**Group of Experts for the revision of the IMO/ILO/UNECE
Guidelines for Packing of Cargo Transport Units**

**Outcome of the eighteenth session of IMO Sub-Committee on
Dangerous Goods, Solid Cargoes and Containers**

Report of the IMO Working Group on Container Safety (DSC 18/WP.3)

REVISION OF THE GUIDELINES FOR PACKING OF CARGO TRANSPORT UNITS

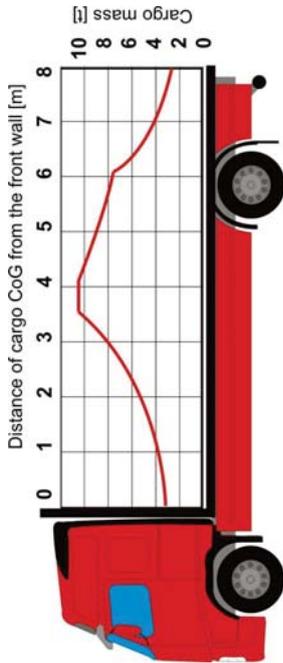
Paragraph 2.2.2.3: in order to use the unique term "friction factor", amend as follows:

"2.2.2.3 The friction values given in appendix 3 are valid for swept clean dry or wet surfaces free from frost, ice, snow, oil and grease. When a combination of contact surfaces is missing in the table in appendix 3 or if its friction factor ~~coefficient of friction~~ can't be verified in another way, the maximum friction factor to be used in calculations is 0.3. If the surface contact is not swept clean, the maximum friction factor to be used is 0.3 or the value in the table, when this is lower. If the surface
